NOTICE OF ACCEPTANCE (NOA)

Series PAN 2000 & 2400 Steel Sectional Garage Door up to 16ft-2in Wide with Optional EPS Insulation

APPROVAL DOCUMENT: Drawing No. **WL-2000-0194-08-48-52M-D**, titled "16'-2" PAN 2000 & 2400 Series HVHZ Wind Load Sectional Door", sheets 1 through 3 of 3, dated 03/11/2015, with revision **C** dated 10/12/2020, prepared by Haas Door Company, signed and sealed by John E. Scates, P.E., bearing the Miami-Dade County Product Control revision stamp with the Notice of Acceptance number and expiration date by the Miami-Dade County Product Control Section.

**NOA-No. 20-1104.07
Expiration Date: February 11, 2026
Approval Date: January 21, 2021
Page 1**

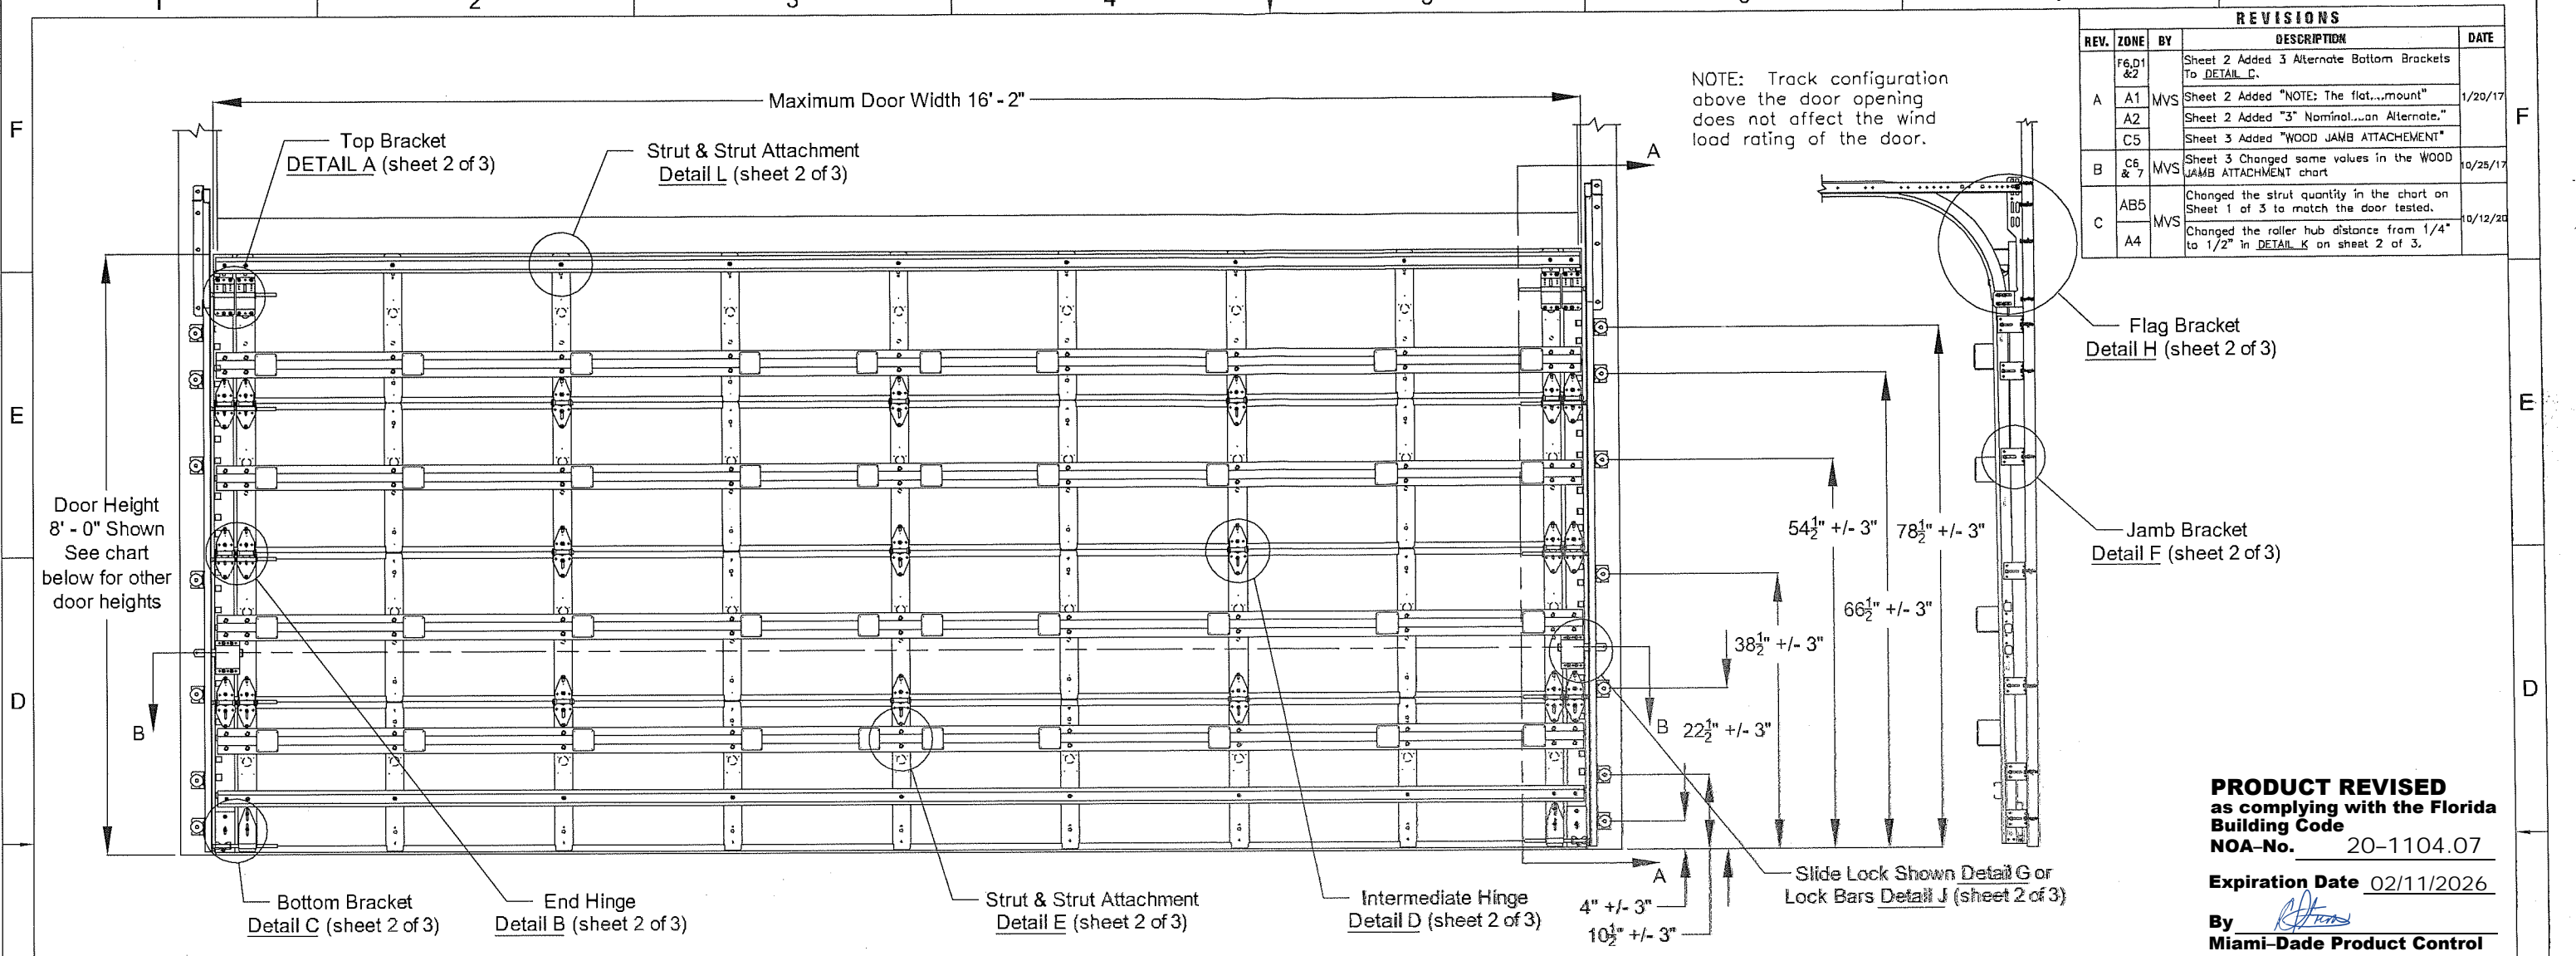
| REVISIONS | | | | |
|-----------|--------|-----|---|----------|
| C | AB5 | | Changed the strut quantity in the chart on Sheet 1 of 3 to match the door tested. | |

DETAIL C

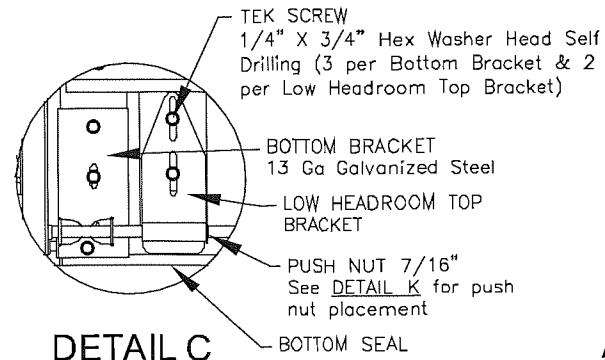
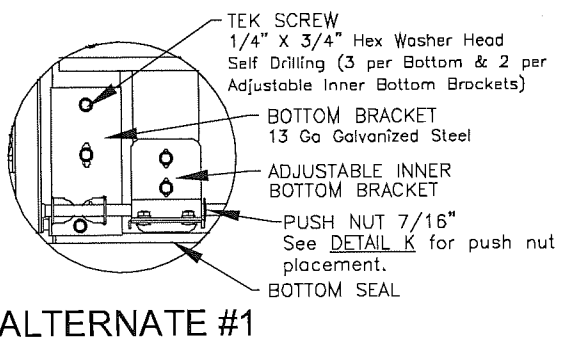
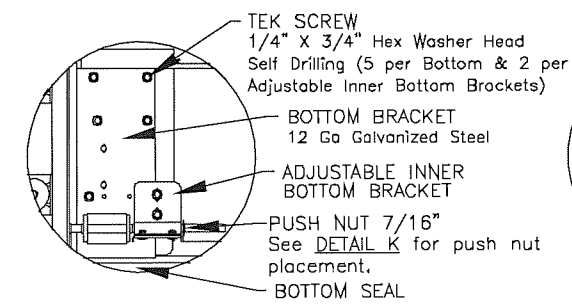
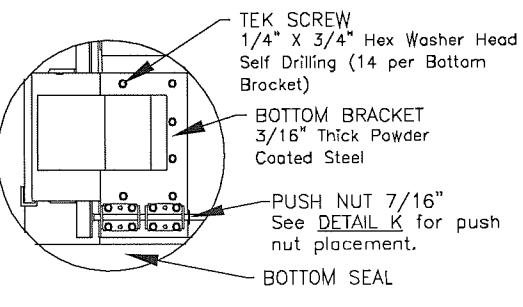
| REVISIONS | | | | |
|-----------|--------|-----|---|----------|
| F6,D1 & 2 | | | Sheet 2 Added 3 Alternate Bottom Brackets To <u>DETAIL C</u> . | |

DETAIL K

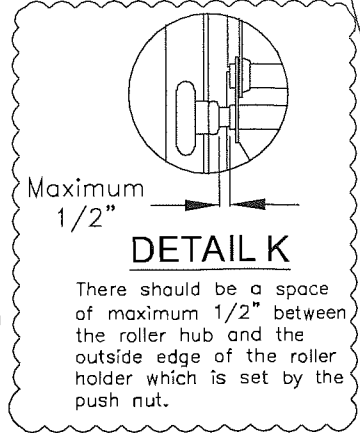
| REVISIONS | | | | |
|-----------|--------|-----|---|----------|
| | A4 | MVS | Changed the roller hub distance from 1/4" to 1/2" in <u>DETAIL K</u> on sheet 2 of 3. | 10/12/20 |
